October 8, 2025 Project No. 19126620

RESPONSE TO MINISTRY OF NATURAL RESOURCES REVIEW COMMENTS ON PROPOSED HIGHLAND LINE PIT TECHNICAL REPORTS, TOWNSHIP OF LANARK HIGHLANDS, ONTARIO (AGGREGATE RESOURCES ACT APPLICATION #626599)

Upon review of the responses prepared by WSP and Cambium, MNR provided further comments dated March 11, 2025 as part of their objection form (refer to **Attachment 2**). The March 11, 2025 comments provided by MNR are presented below in *italics* followed by the responses by WSP.

**OPERATIONS PLAN NOTES**

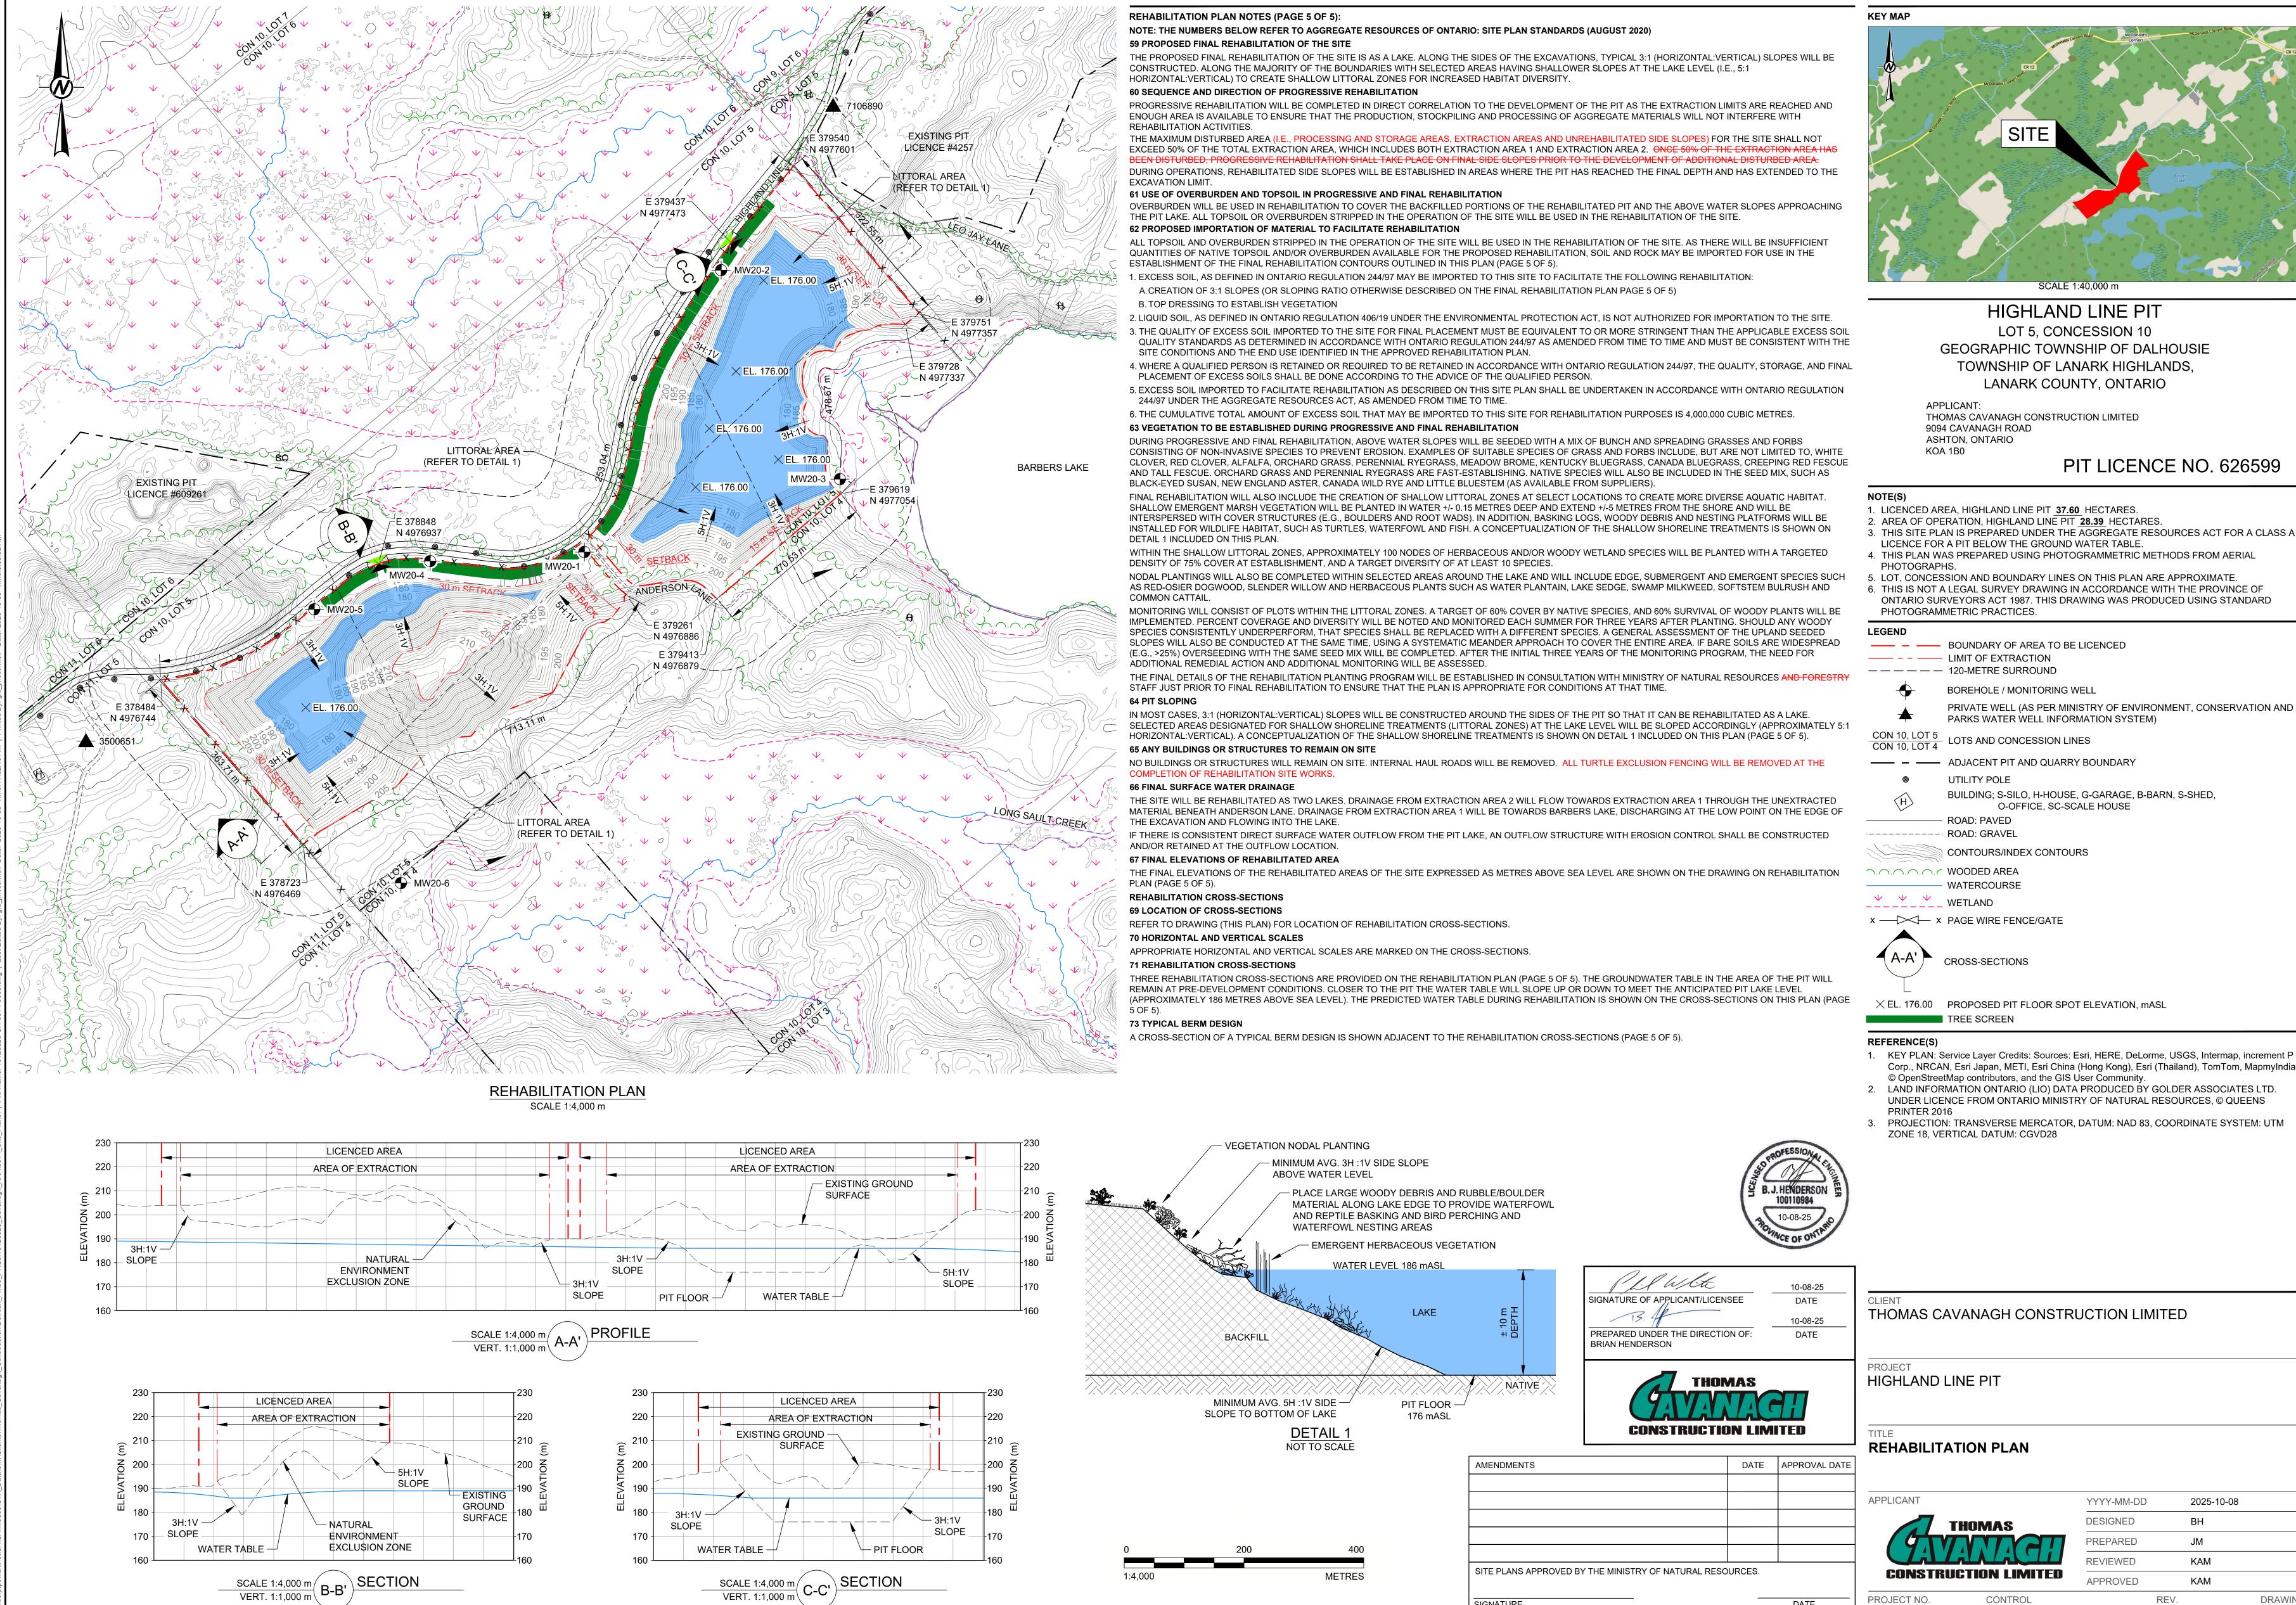
Please note that this comment is resolved, pending verification that any recommendations from DFO have been incorporated on the site plan, as required.

Partially resolved – To support the progressive rehabilitation of the site, MNR staff support, in-principle, incorporating a 50% maximum disturbed area on the site plan. However, it is recommended for clarity that the revision to note 60 on the Rehabilitation Plan describe what the 'disturbed area' is intended to represent (e.g., processing and storage areas, stripped areas, extraction areas, and unrehabilitated side slopes etc.).

The second sentence in the revision to note 60 also indicates that progressive rehabilitation will be initiated once the 50% maximum disturbed area is reached. This would appear to contradict the first sentence in this note, which suggests that progressive rehabilitation will be ongoing when there is available space in each phase (e.g., in Extraction Area 1 and 2). To ensure clear direction is provided on the site plan, it is recommended that the second sentence in the revised note be removed.

All recommendations form DFO have been added to Page 4 of 5 of the Site Plan. Please refer to Technical Report Recommendations under Natural Environment.

Site Plan Note 60 has been altered as follows to address this comment:

The above additions to the monitoring program have been included in the *Technical Report Recommendations* and/or *Monitoring - Water Report and Agency Comments* on the Operations Plan Notes (Page 4 of 5) of the Site Plans in **Attachment 6**.
